ADDENDUM NUMBER 2
ITB 16-ES-002 - US HWY #1 AND SR #442 FDOT LANDSCAPE BEAUTIFICATION PROJECT
CITY OF EDGEWATER

US 1 AND SR442 FDOT LANDSCAPE BEAUTIFICATION

US 1 AND SR442 BEAUTIFICATION
IRRIGATION PLANS
LAYOUT SHEET
VOLUSIA COUNTY, FLORIDA
CITY OF EDGEWATER

**US 1 AND SR442 BEAUTIFICATION
IRRIGATION PLANS**

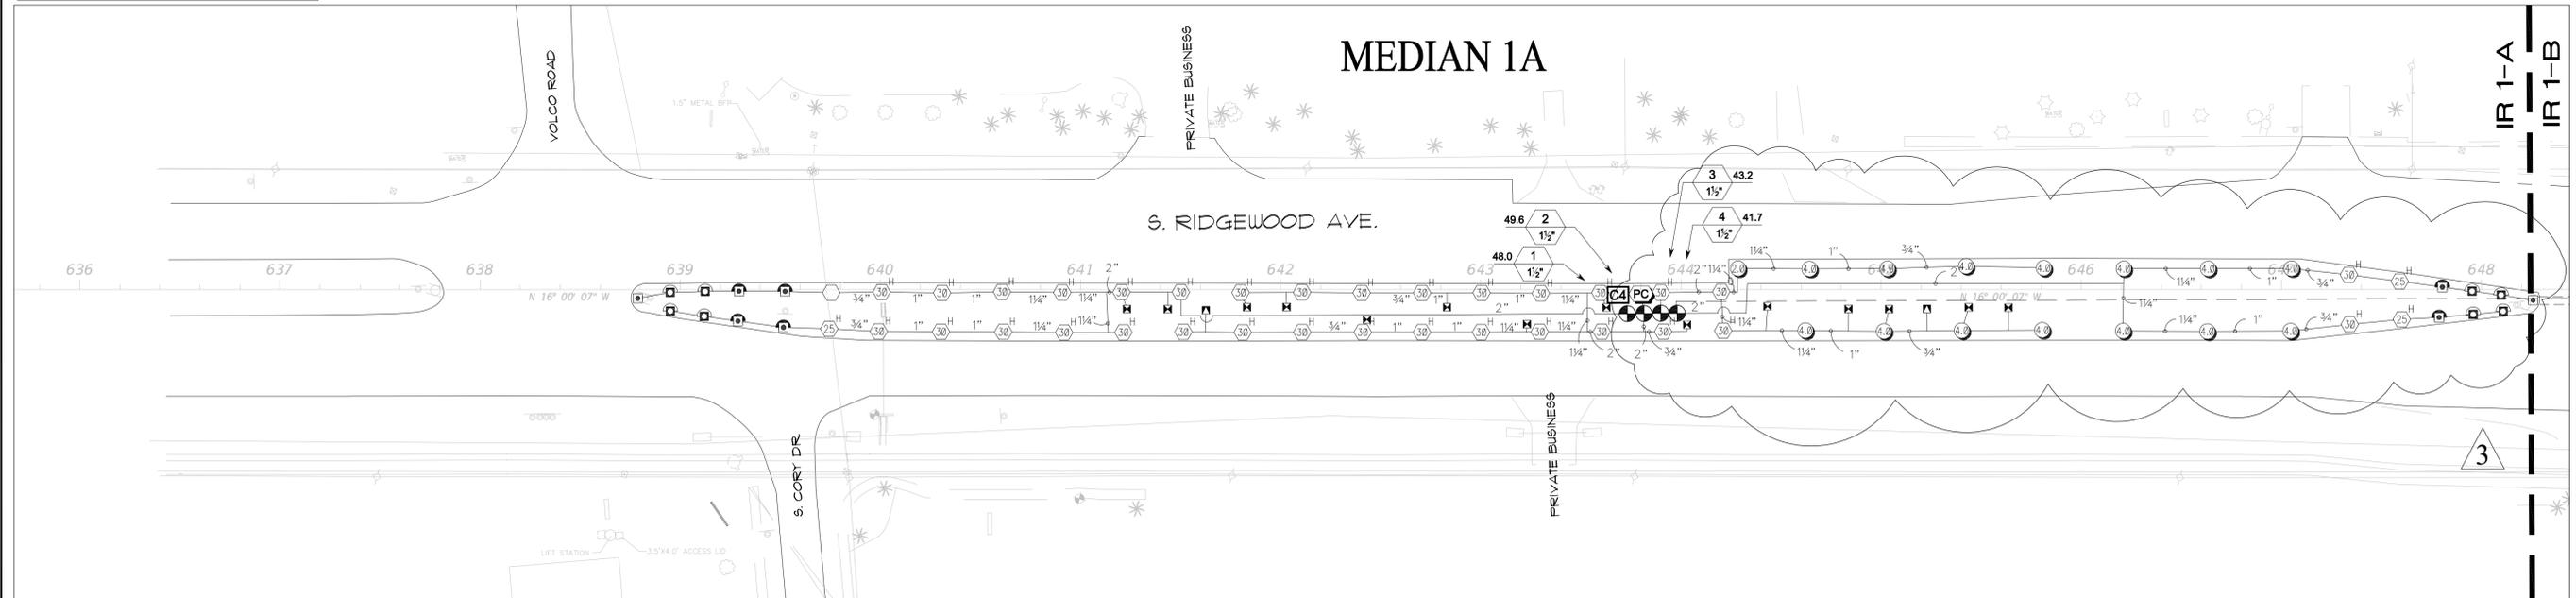
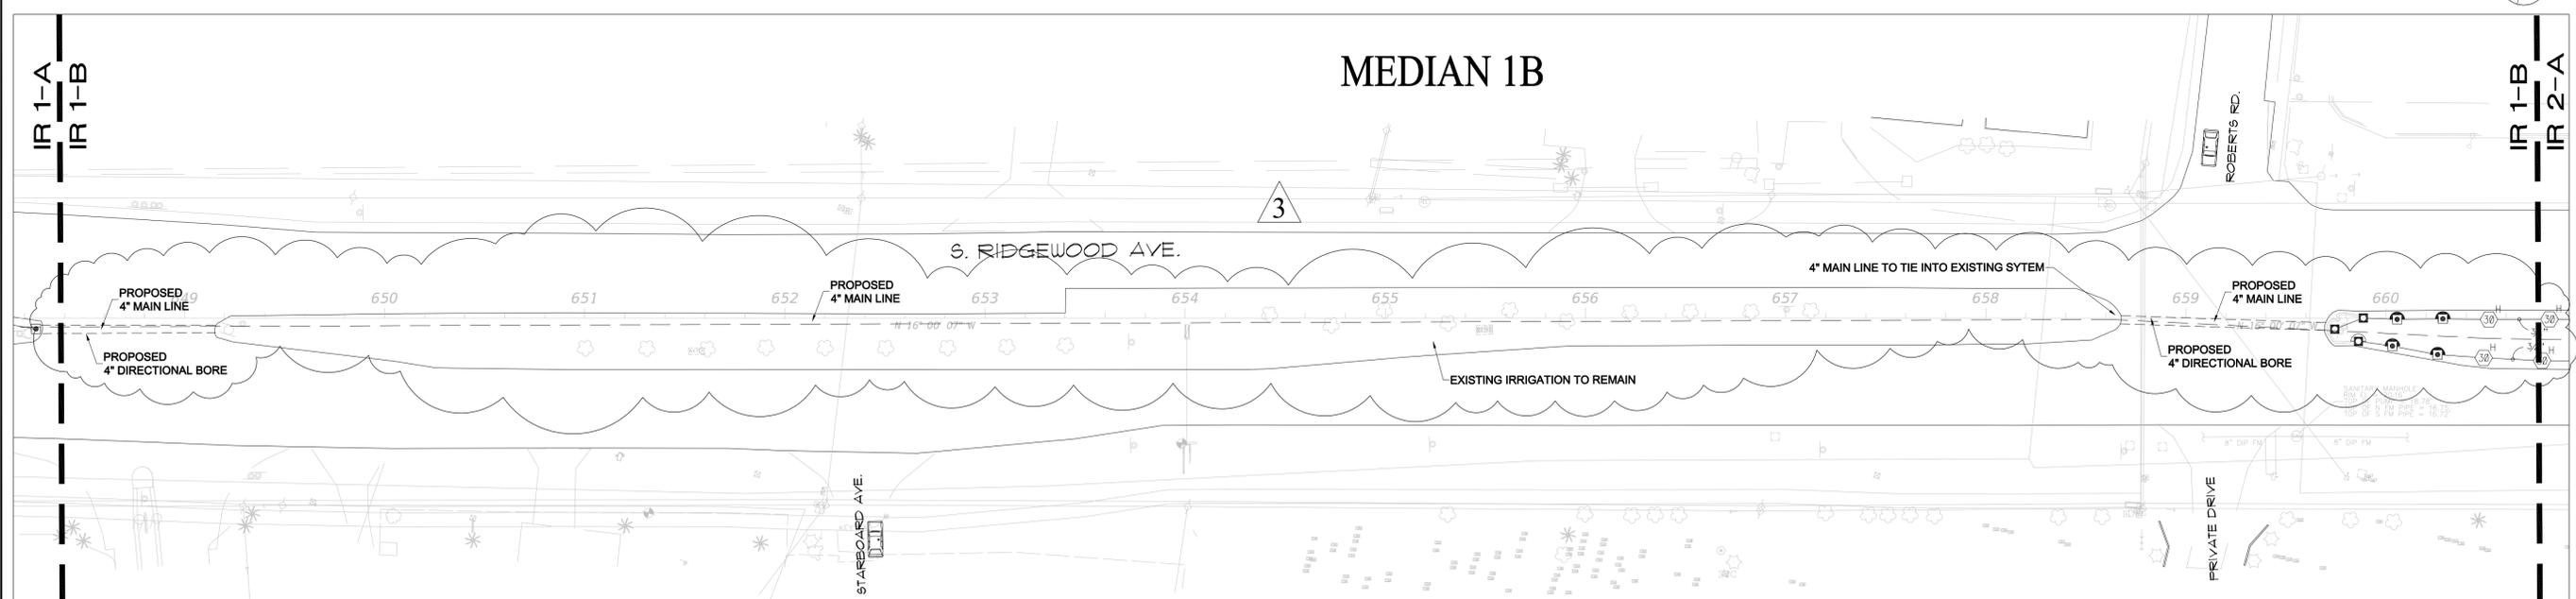
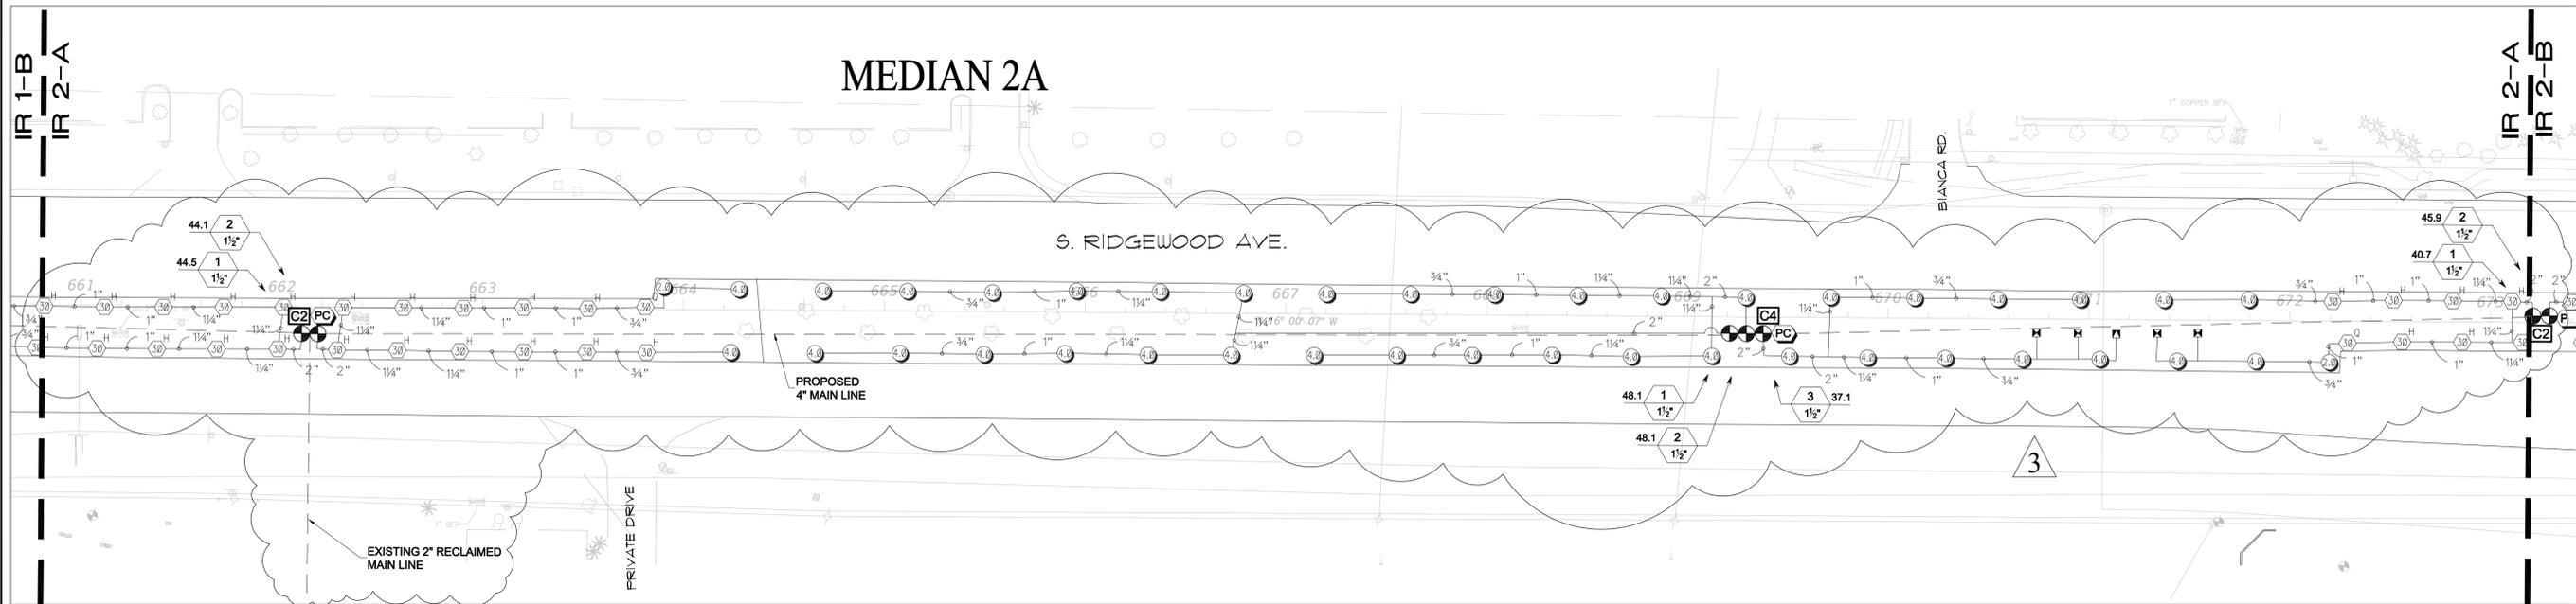
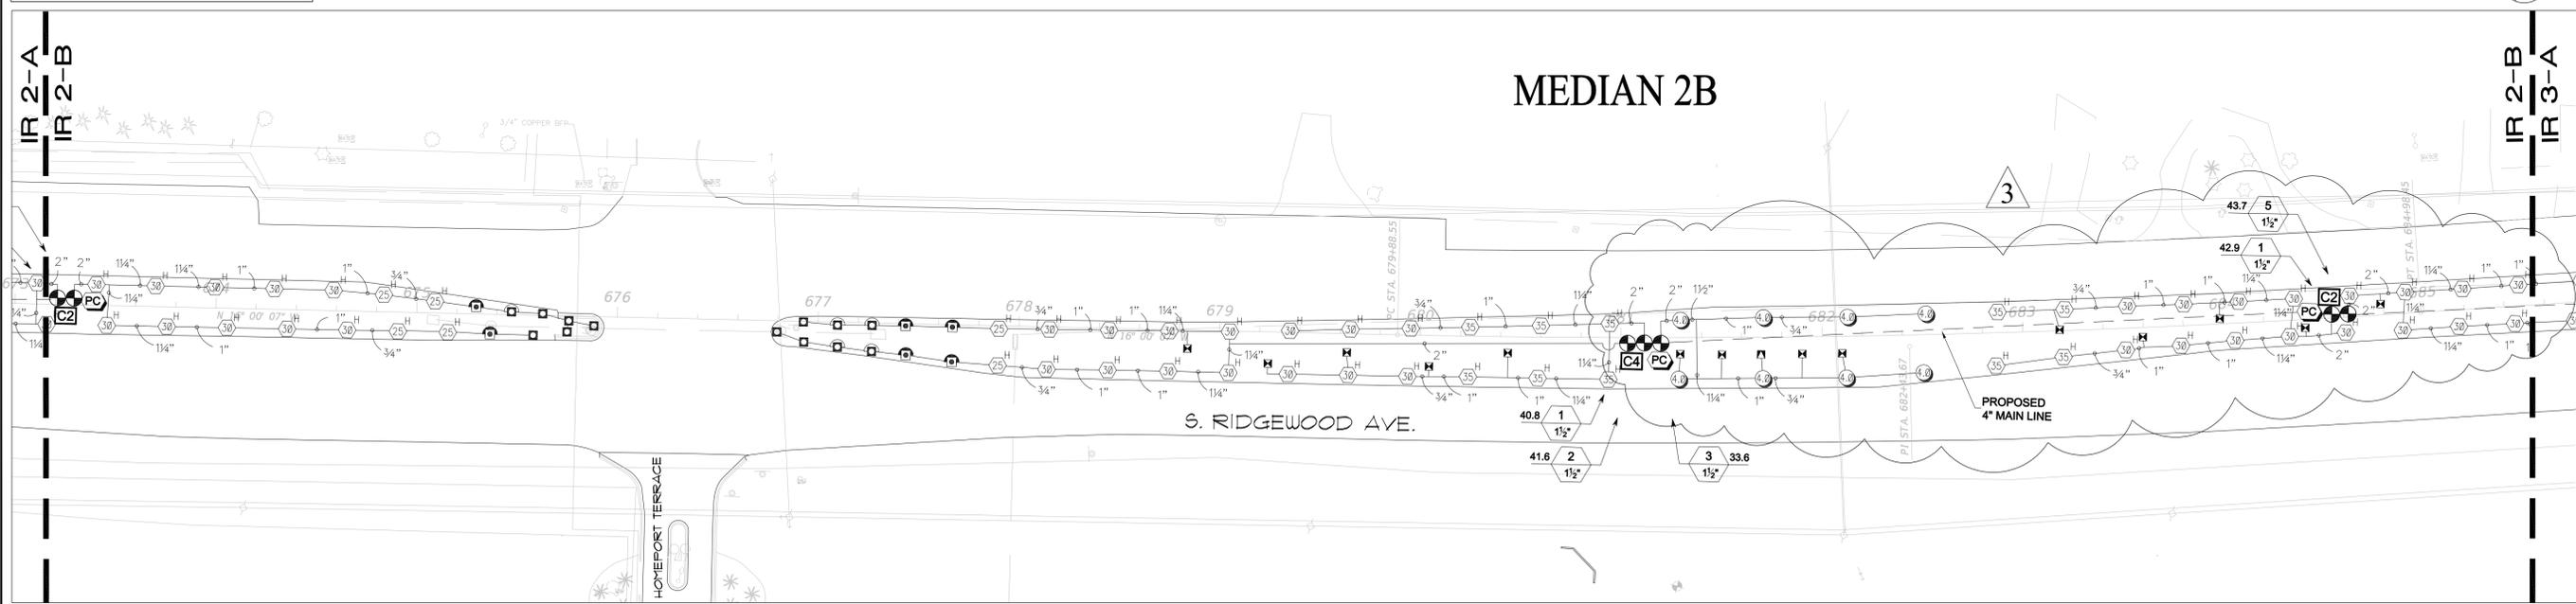
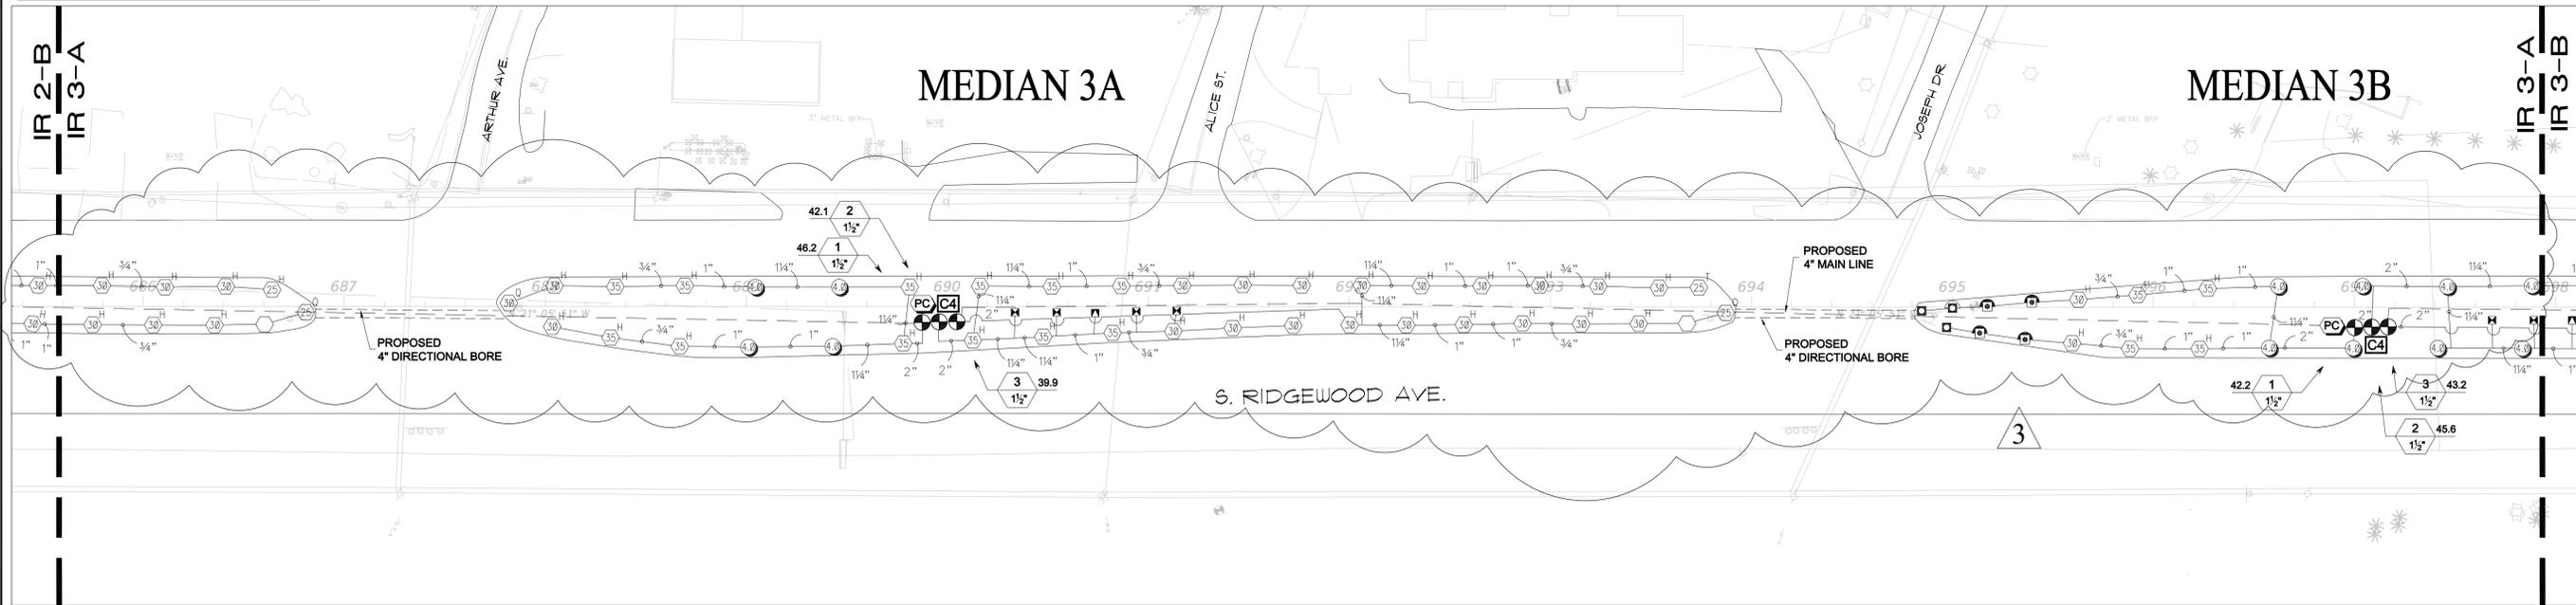
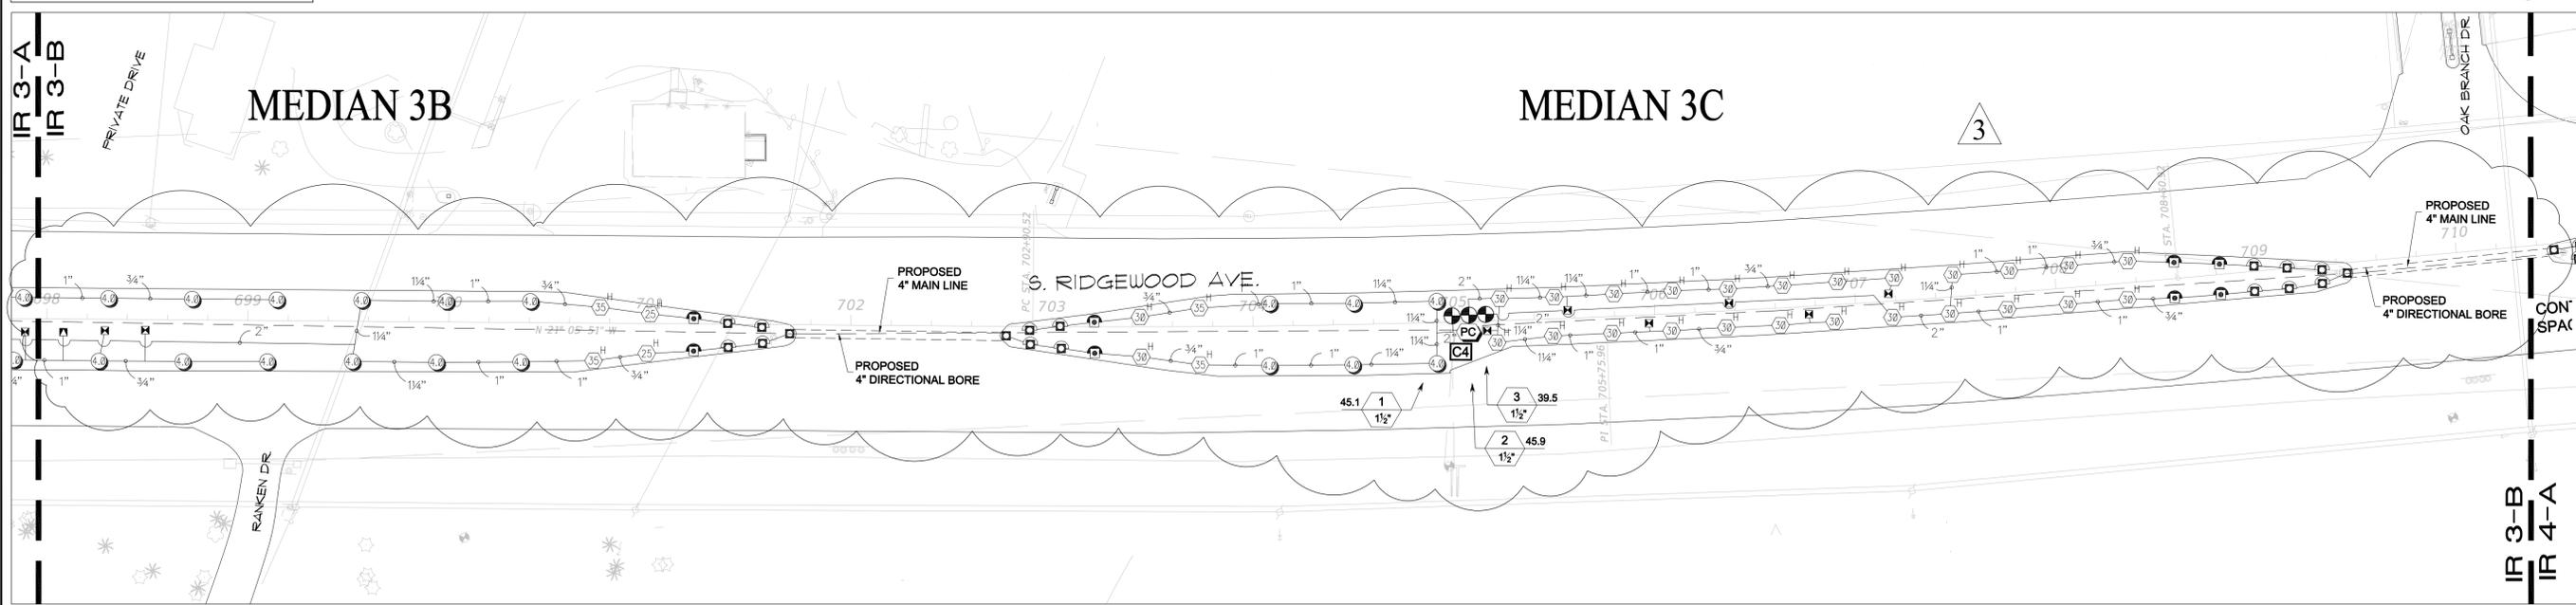
Q2. Designer refers to “PC” as a point to connect to an (existing ?) 4” mainline in multiple areas, this implies that there is an existing 4” mainline, is this correct? There is “no” mainline shown to be installed on the drawings.

Q3. Also you are requesting 4” directional to connect the medians which would imply that there is no mainline existing and therefore one should be installed, yet none is show on the plans or listed on the irrigation schedule?

Q4. Listed on the bid tab “only” is 2,400 l.f. of 3” class 200 SDR 21 gasketed pvc, is this to be the mainline, why is it not shown on the plan specifically where it is to be installed? In what medians is the 3” to be installed and where does the water supply originate from?

A2. Please see attached revised plans.

A3. Please see attached revised plans.

A4. Please see attached revised plans.
